## PRODUCT/PROCESS CHANGE NOTICE (PCN)

<b>PCN #:</b> <b>TB1405-01</b> <b>DATE:</b> <b>July 7, 2014</b> <b>Product Affected:</b> <b>TQFP-44, TQFP-64</b> <b>shipped in Tape &amp; Reel</b> (Refer to Attachment II for affected part#) <b>Date Effective:</b> <b>October 7, 2014</b>	<b>MEANS OF DISTINGUISHING CHANGED DEVICES:</b> <input type="checkbox"/> Product Mark <input type="checkbox"/> Back Mark <input type="checkbox"/> Date Code <input checked="" type="checkbox"/> Other        Shipment starting from October 7, 2014.
--	--

### ATTACHMENT I - PCN #: TB1405-01

**From:** Carrier Tape (P8-300-E64) - Pocket Dimensions

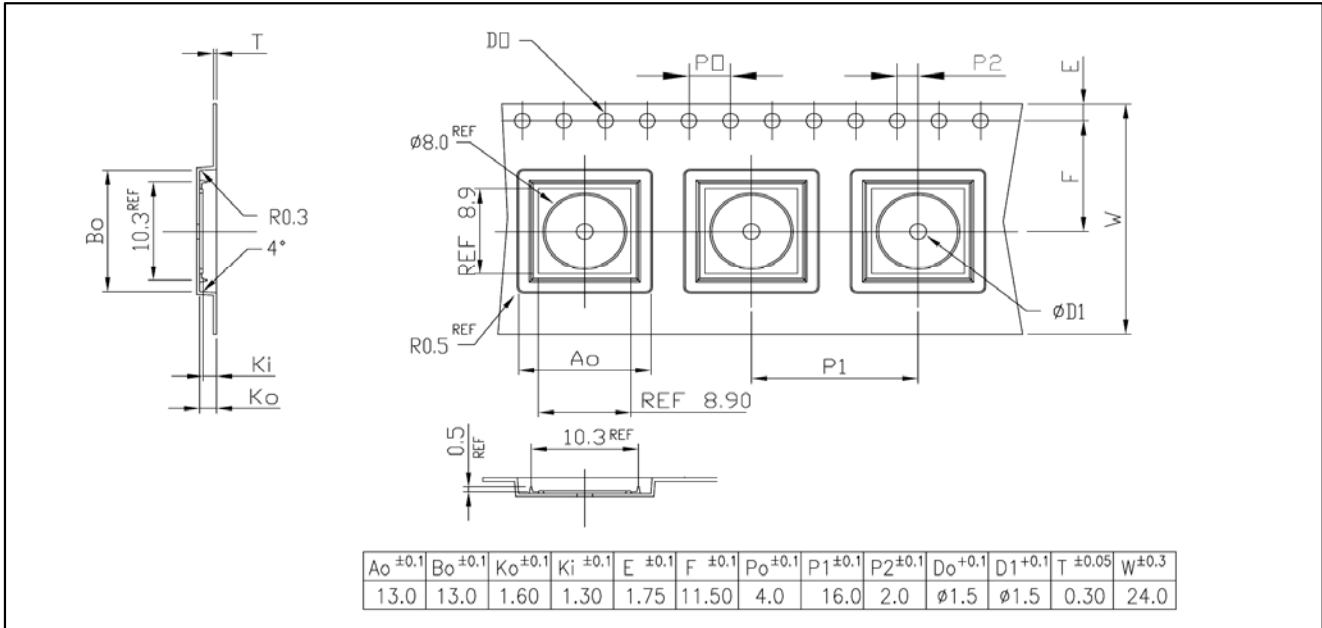
The new carrier tape has changes in pocket design and dimensions and complies with the requirements of EIA-481-D standard.

Refer to Table 2, Figure 1 and 2 for the comparison of the existing and new carrier tape in terms of carrier tape pocket dimensions and pocket designs as well as quantity per reel respectively.

**Figure1: Illustration of Carrier Tape Pocket Dimensions**

Attachment III - Existing Carrier Tape Drawing

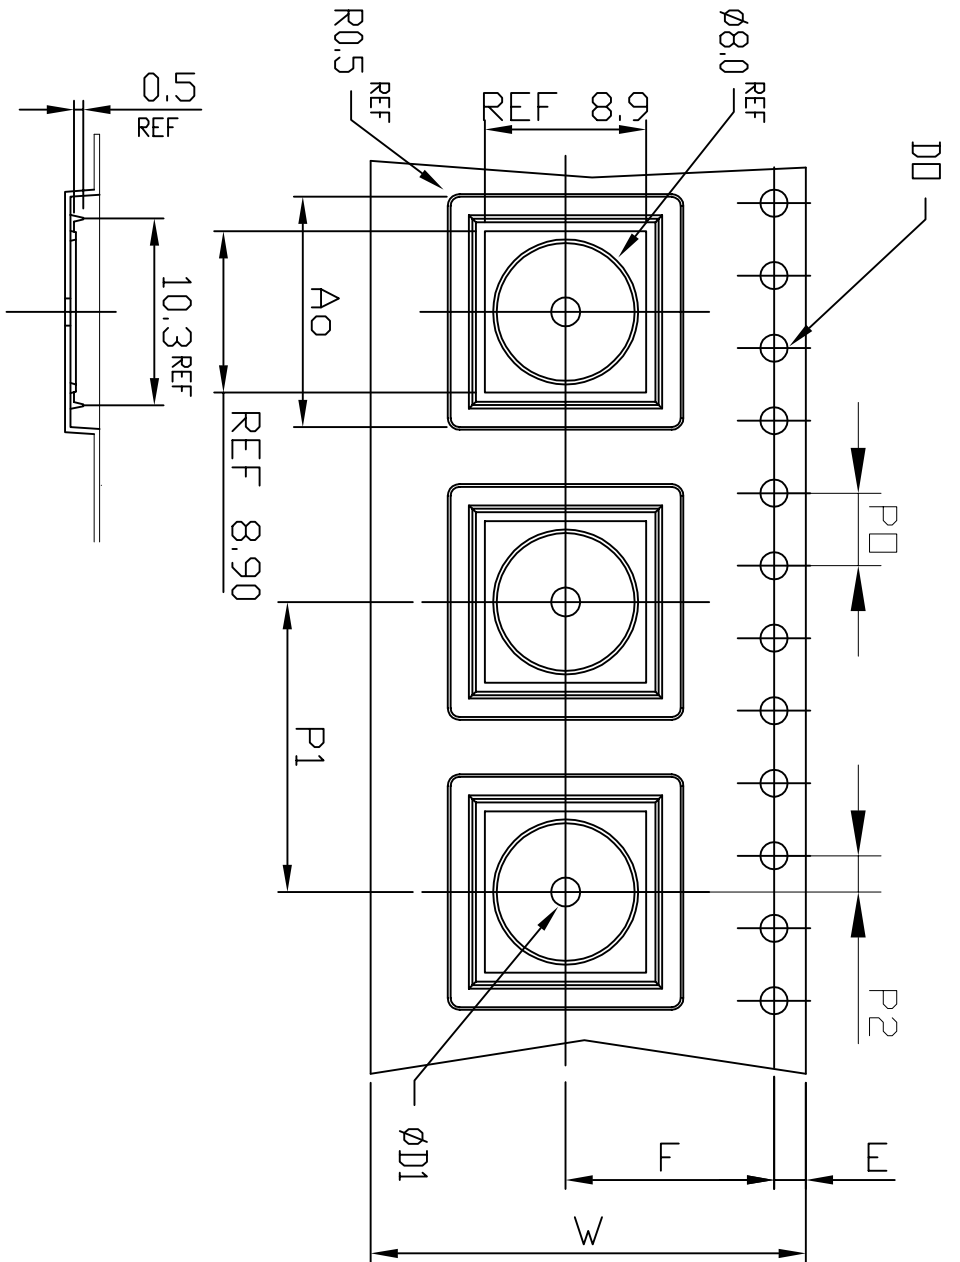
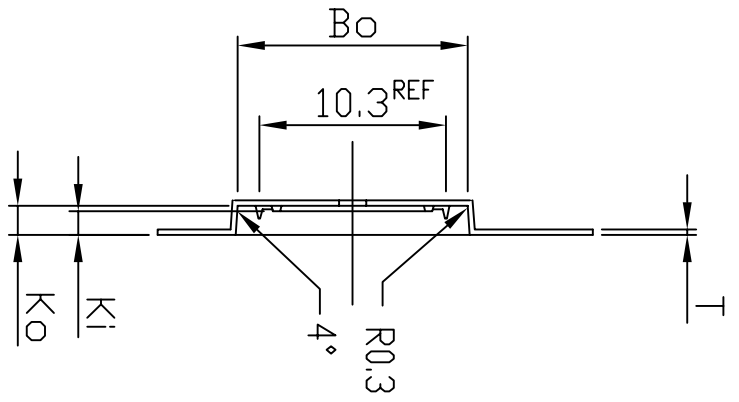
\*Note: All dimensions are in mm. Refer to the attached carrier tape drawings for more details.
